ST. TAMMANY PARISH

Addendum No.: 2

Bid#: 24-35-2

Project Name: Diversified Water Well Pretreatment System

B C-011 INTERIOR ELEVATION - CHEMICAL FEED ROOM
SCALE: 3/8" = 1'-0"

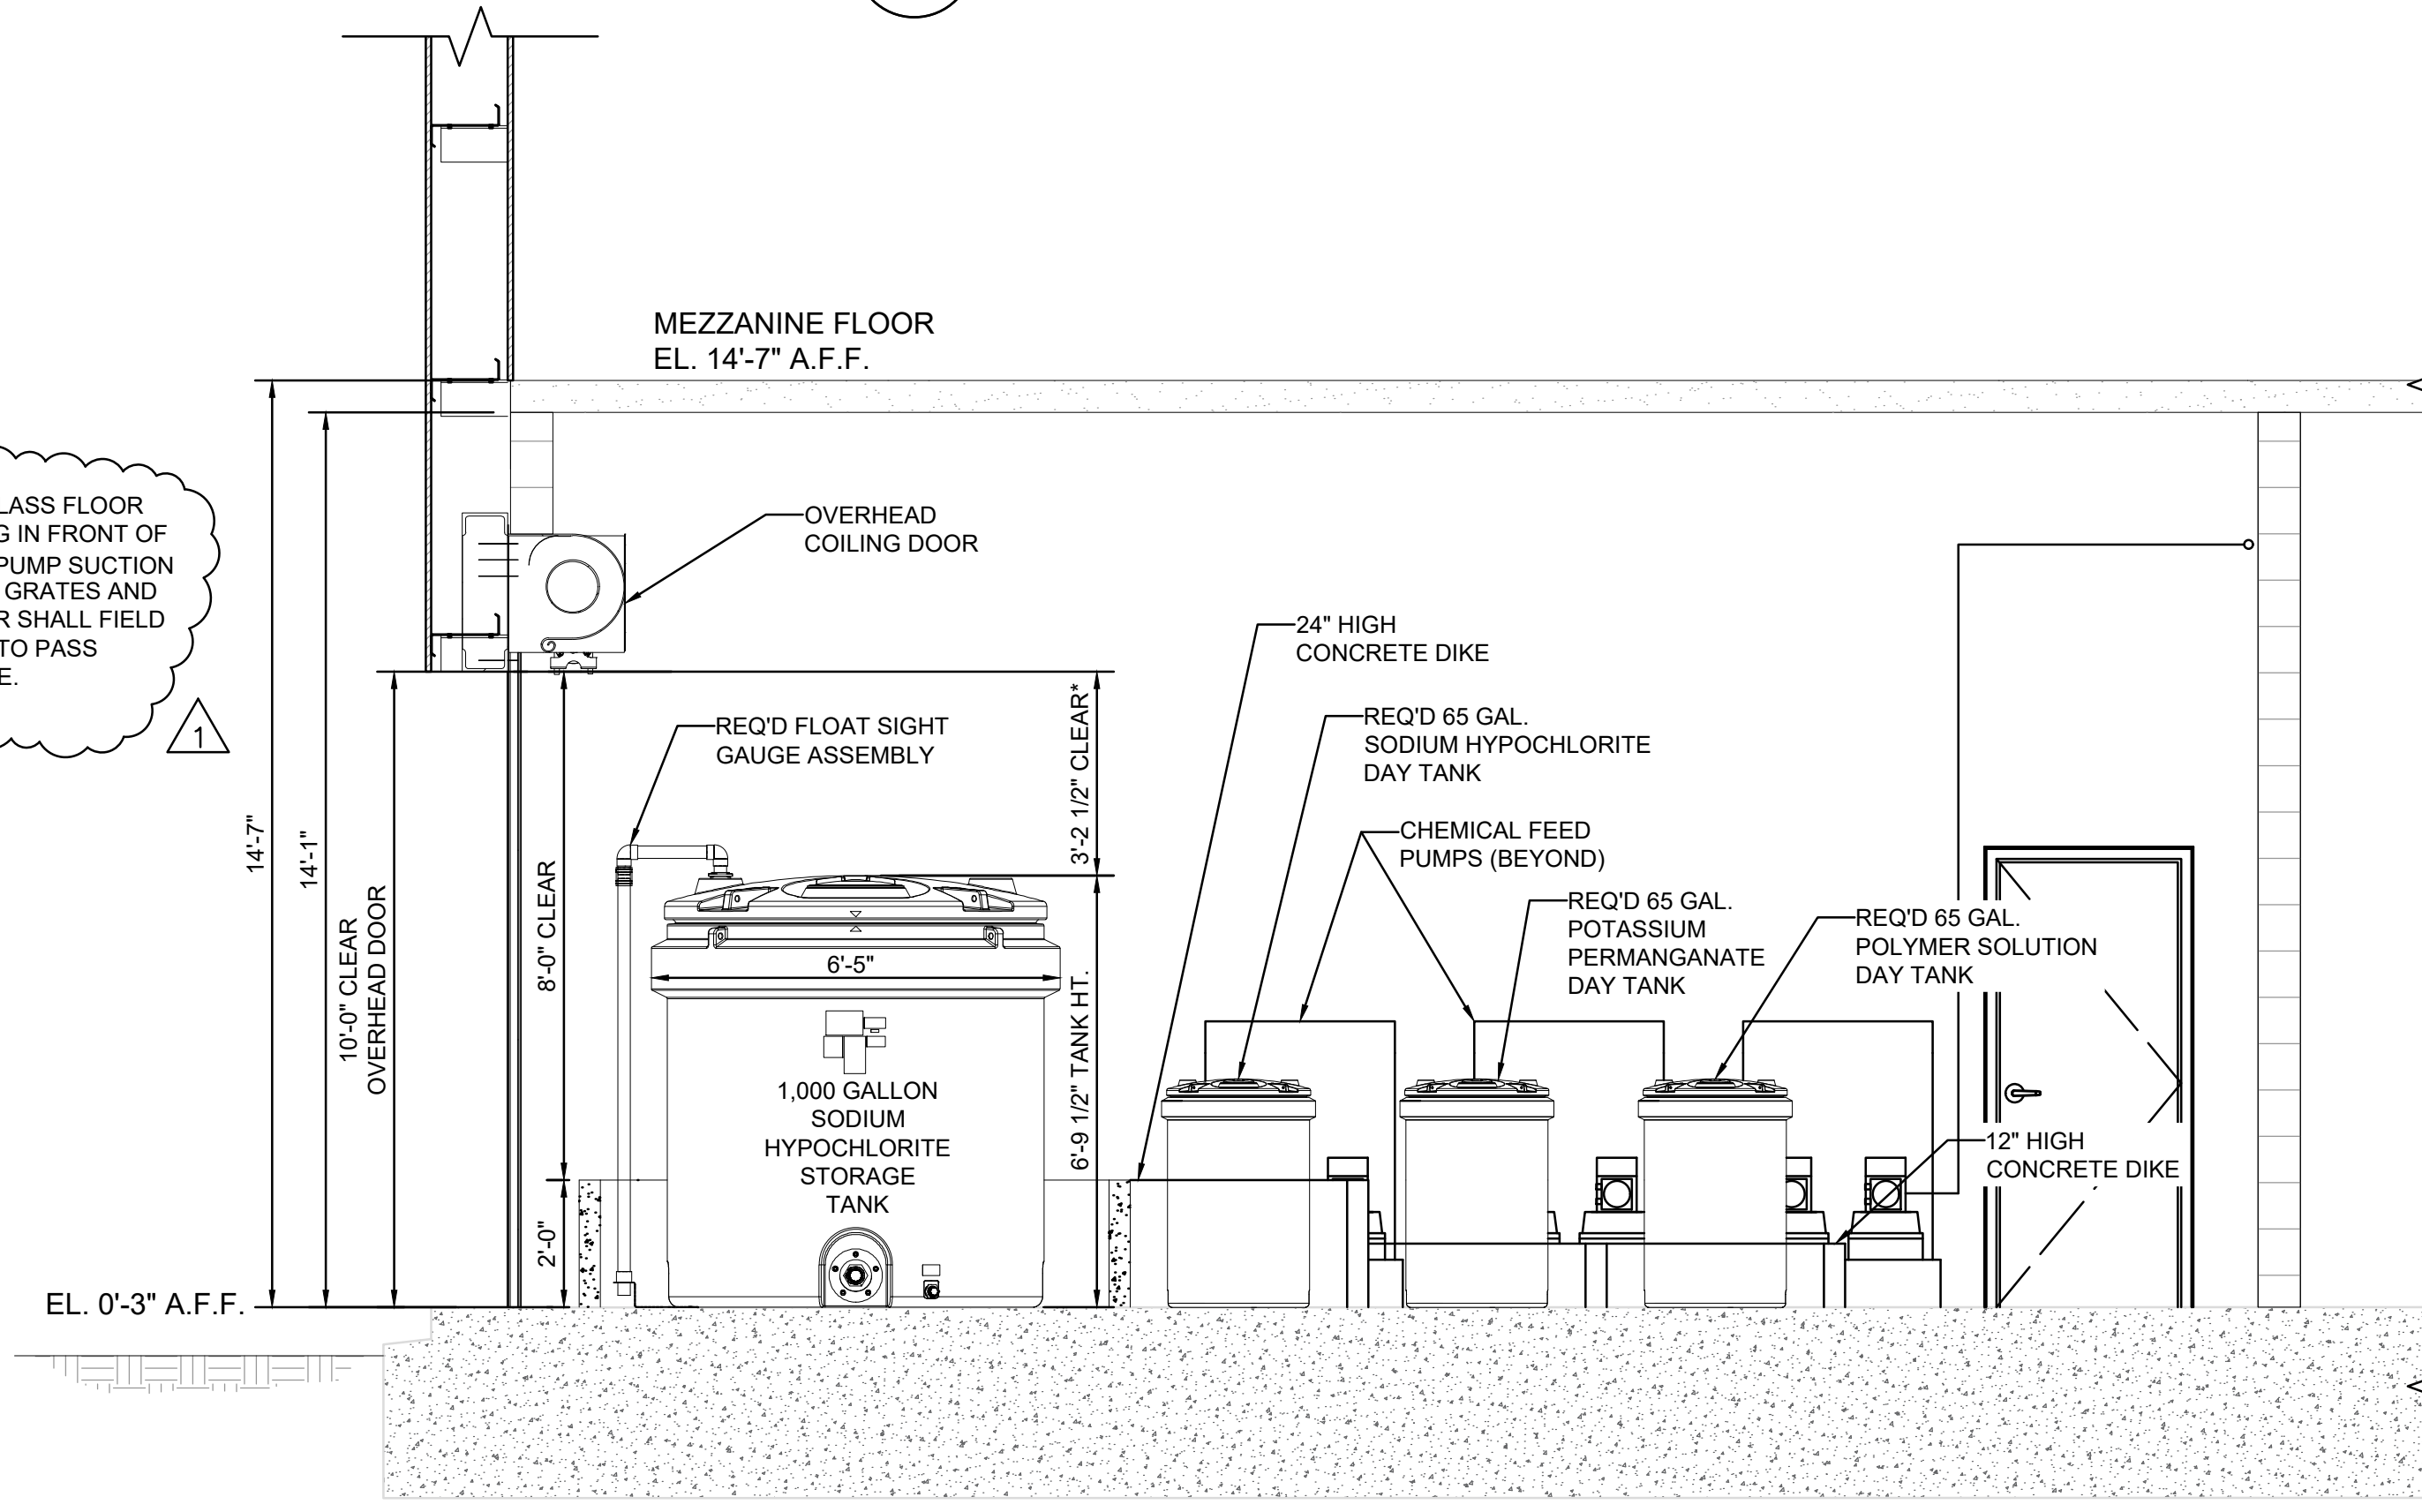
36. **Replace** Plan Sheet C-011 Chemical Facilities Plan and Elevation with the attached revised Sheet C-011, showing the revised location of Door #102B in the Chemical Feed Room, the addition of fiberglass floor grating on the chemical room floor, and the 12,000 BTU mini-split A/C system is deleted from the project.

SHEET NO.
S-002
SHEET 38 OF 92

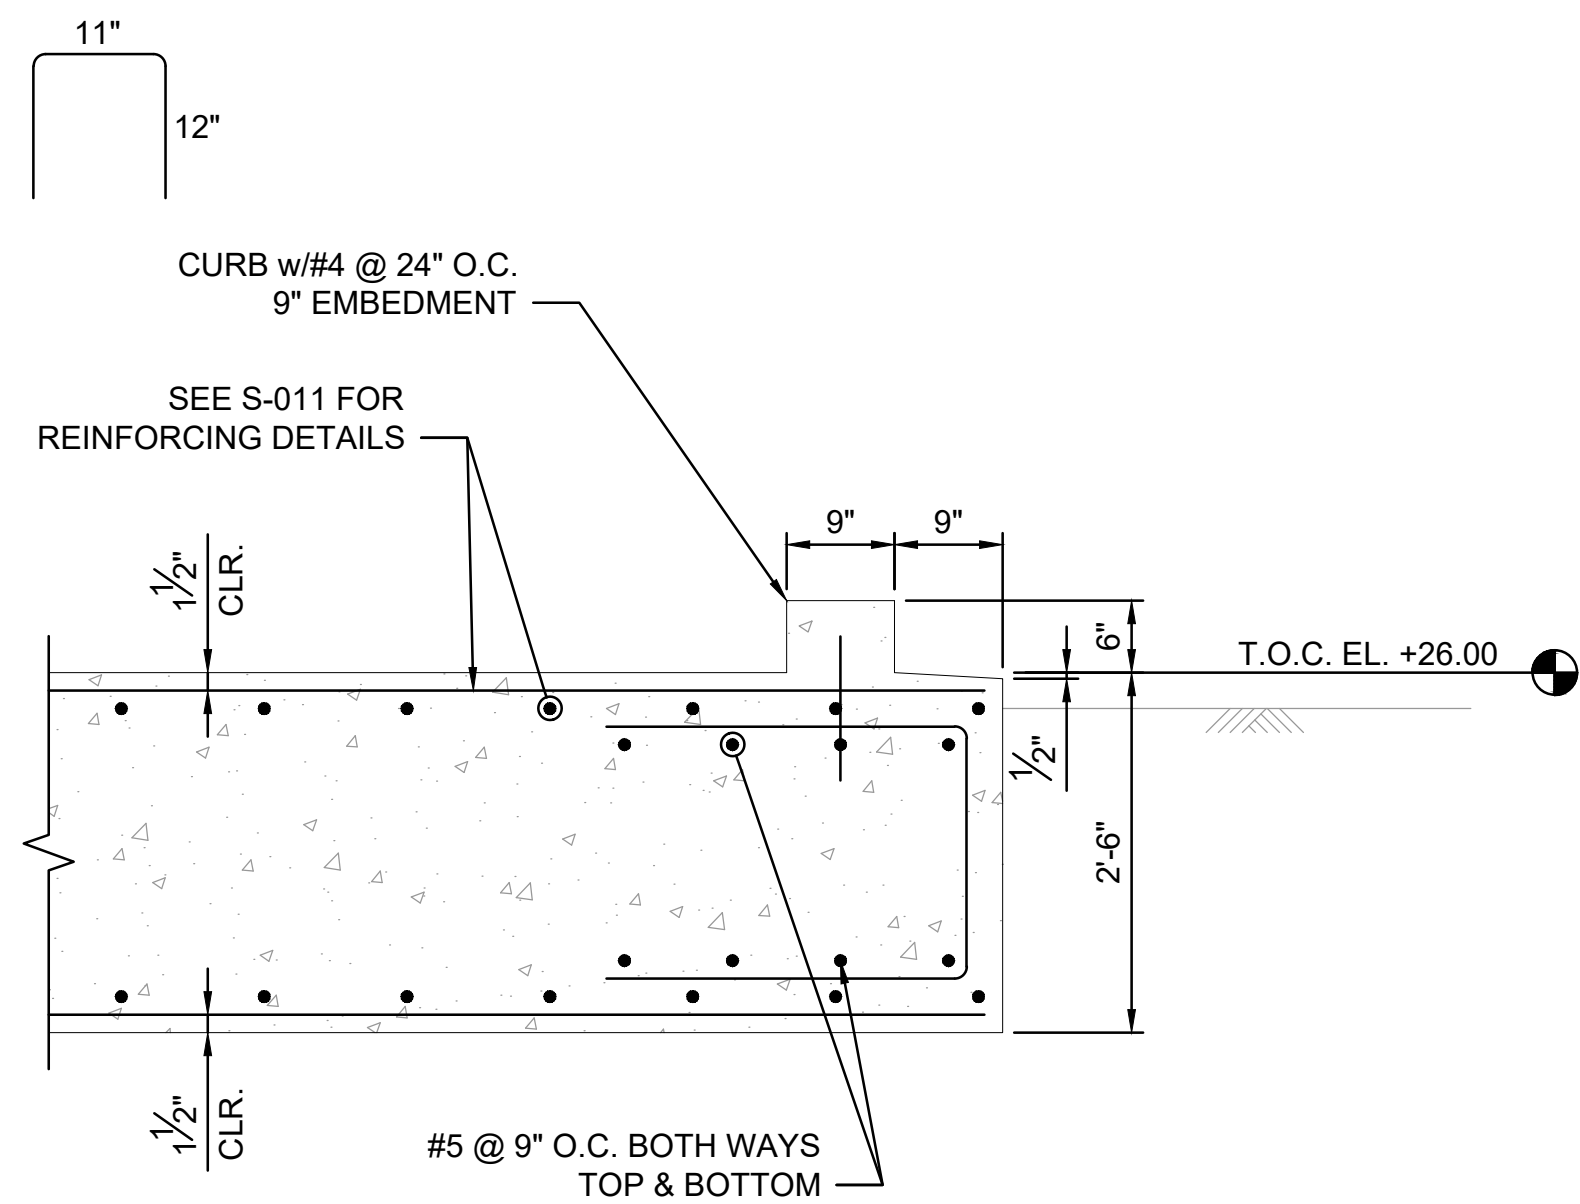
37. **Replace** Plan Sheet S-002 Foundation Plan with the attached revised Sheet S-002, revised to include the adjusted Door #102B location.
38. **Replace** Plan Sheet S-012 Foundation Details with the attached revised Sheet S-012, showing revised Detail 9/S-012 Typical Concrete Containment Dike with additional notes.
